UNITED STATES PATENT AND TRADEMARK OFFICE

APPLICATION NO.	FILING DATE	FIRST NAMED INVENTOR	ATTORNEY DOCKET NO.	CONFIRMATION NO.
10/801,265	03/16/2004	Jean-Paul Bonnet	1055-04	4747

Office Action Summary	Application No. 10/801,265	Applicant(s) BONNET ET AL.	
	Examiner William H. Rodriguez	Art Unit 3746

DETAILED ACTION

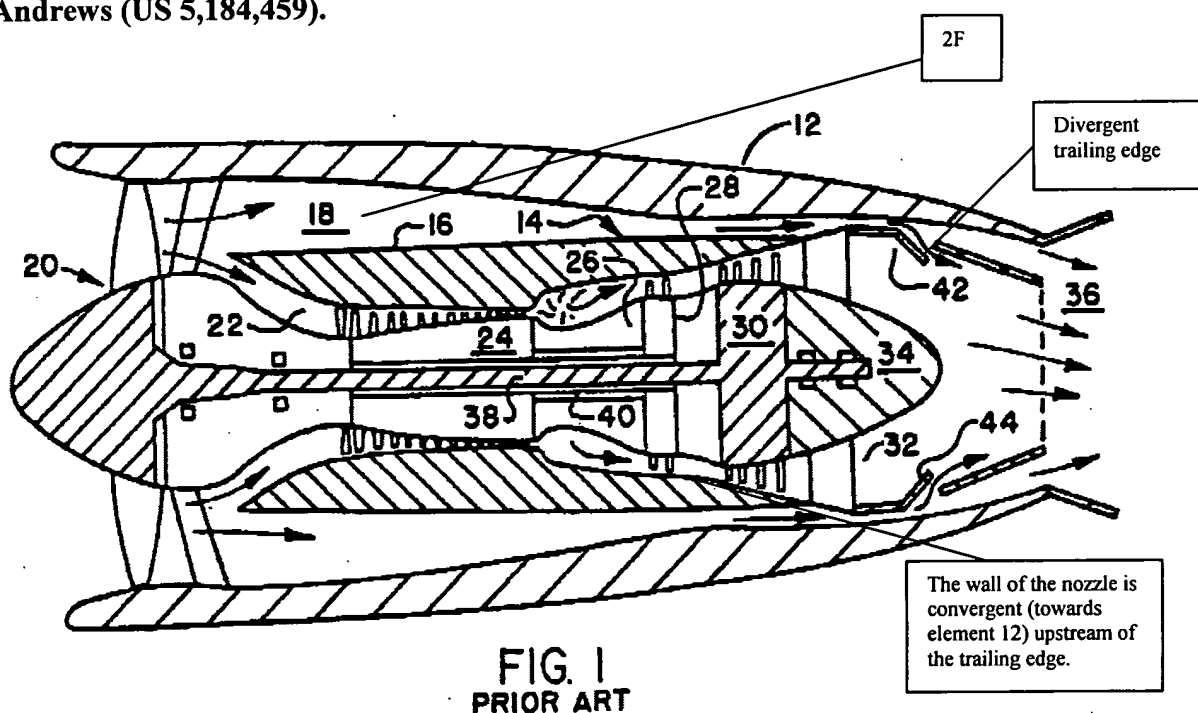
With respect to claim 1, McAndrews teaches an engine having a device 42, 44 for controlling propulsive gas mixing at an outlet of said engine, wherein propulsive jets are composed of a hot primary jet exiting from a nozzle of the engine and a secondary flux (2F) flowing between an external wall of the nozzle and an internal wall of the engine, the device comprising: a divergent trailing edge* on the wall that generates conditions of a separation of the primary jet and a primary jet controller (not show but mentioned, column 3 lines 35, 39) that

enables control of passage of the primary jet from a separated state to a reattached state, and vice versa. See particularly **Figure 1** of McAndrews above.

With respect to claim 2, **McAndrews** teaches that controlling the separation of the primary jet is periodic (elements 42, 44 open and close periodically depending on the mode of operation). See particularly **Figure 1** of McAndrews above.

With respect to claim 11, **McAndrews** teaches that control of the separation of the primary jet is implemented at the trailing edge. See particularly **Figure 1** of McAndrews above.

With respect to claim 12, **McAndrews** teaches that control of the separation of the primary jet is implemented to generate a symmetrical flow at the outlet of the engine. See particularly **Figure 1** of McAndrews above.

With respect to claim 13, **McAndrews** teaches that the trailing edge has an angle with the wall of the nozzle between about 10 and about 30.degree. See particularly **Figure 1** of McAndrews above.

With respect to claim 14, **McAndrews** teaches that the wall of the nozzle is convergent upstream of the trailing edge. See particularly **Figure 1** of McAndrews above.

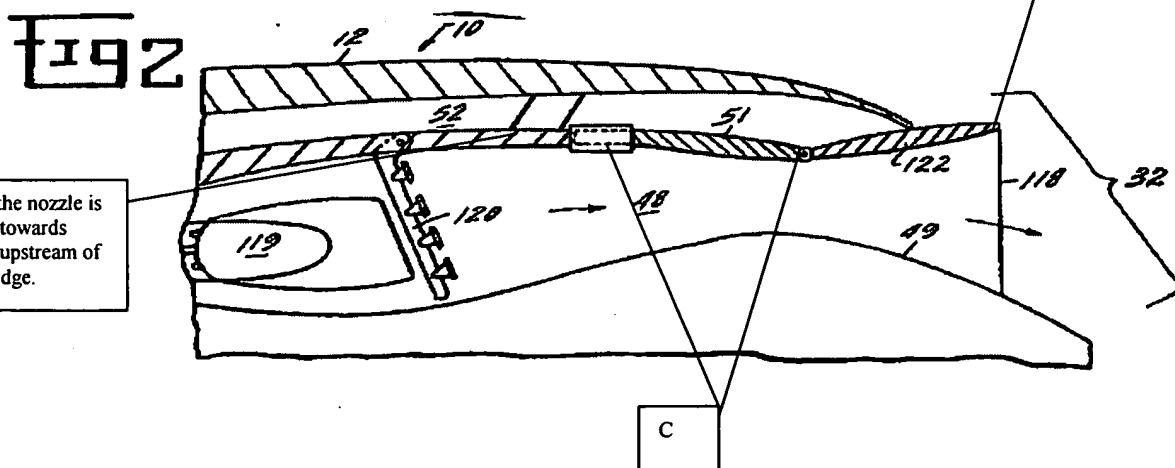
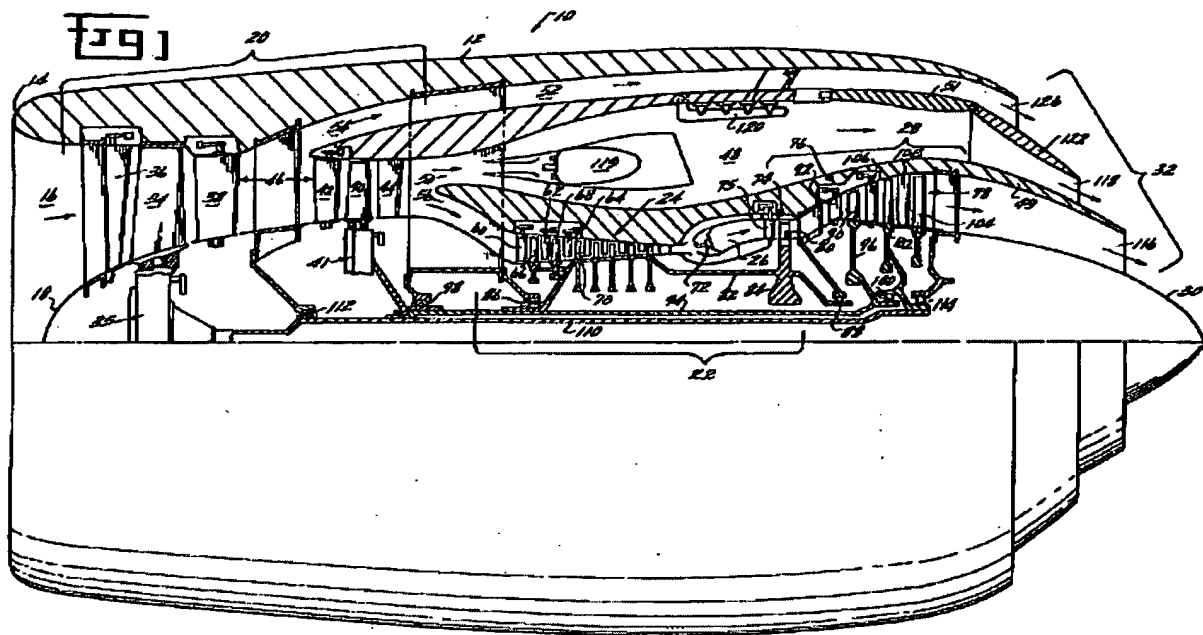
With respect to claim 1, **Koff** teaches an engine having a device 122 for controlling propulsive gas mixing at an outlet of said engine, wherein propulsive jets are composed of a hot primary jet exiting from a nozzle of the engine and a secondary flux (52) flowing between an external wall of the nozzle and an internal wall of the engine, the device comprising: a divergent trailing edge* on the wall that generates conditions of a separation of the primary jet and a primary jet controller (C) that enables control of passage of the primary jet from a separated state to a reattached state, and vice versa. See particularly **Figures 1, 2** of Koff above.

With respect to claim 2, **Koff** teaches that controlling the separation of the primary jet is periodic (element 122 opens and close periodically depending on the mode of operation). See particularly **Figures 1, 2** of Koff above.

With respect to claim 9, **Koff** teaches that the controller C is arranged on all or a part of the circumference of the internal wall of the nozzle. See particularly **Figures 1, 2** of Koff above.

With respect to claim 10, **Koff** teaches that the controller C is arranged on all or a part of the circumference of the external wall of the nozzle. See particularly **Figures 1, 2** of Koff above.

With respect to claim 11, **Koff** teaches that control of the separation of the primary jet is implemented at the trailing edge. See particularly **Figures 1, 2** of Koff above.

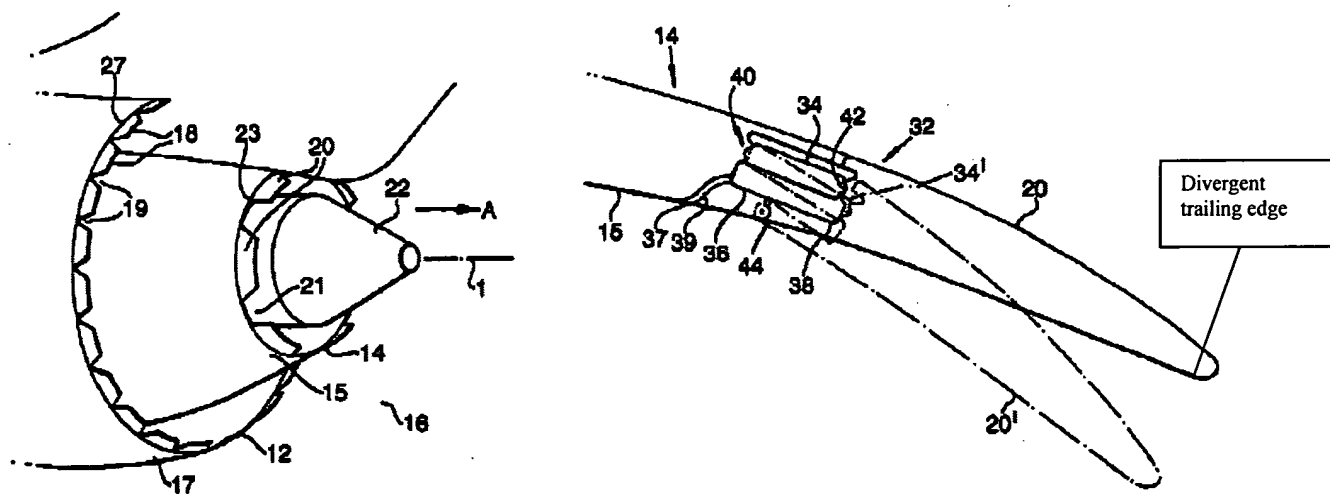
With respect to claim 1, **Birch** teaches an engine having a device 20 for controlling propulsive gas mixing at an outlet of said engine, wherein propulsive jets are composed of a hot primary jet exiting from a nozzle of the engine and a secondary flux flowing between an external wall of the nozzle and an internal wall of the engine, the device comprising: a divergent trailing edge* on the wall that generates conditions of a separation of the primary jet and a primary jet controller (34) that enables control of passage of the primary jet from a separated state to a reattached state, and vice versa. See particularly **Figures 2, 5** of **Birch** above.

With respect to claim 2, **Birch** teaches that controlling the separation of the primary jet is periodic (element 20 opens and close periodically depending on the mode of operation). See particularly **Figures 2, 5** of Birch above.

With respect to claim 9, **Birch** teaches that the controller C is arranged on all or a part of the circumference of the internal wall of the nozzle. See particularly **Figures 2, 5** of Birch above.

With respect to claim 11, **Birch** teaches that control of the separation of the primary jet is implemented at the trailing edge. See particularly **Figures 2, 5** of Birch above.

With respect to claim 12, **Birch** teaches that control of the separation of the primary jet is implemented to generate a symmetrical flow at the outlet of the engine. See particularly **Figures 2, 5** of Birch above.

With respect to claim 13, **Birch** teaches that the trailing edge has an angle with the wall of the nozzle between about 10 and about 30.degree. See particularly **Figures 2, 5** of Birch above.

With respect to claim 14, **Birch** teaches that the wall of the nozzle is convergent upstream of the trailing edge. See particularly **Figure 1** of Birch above.
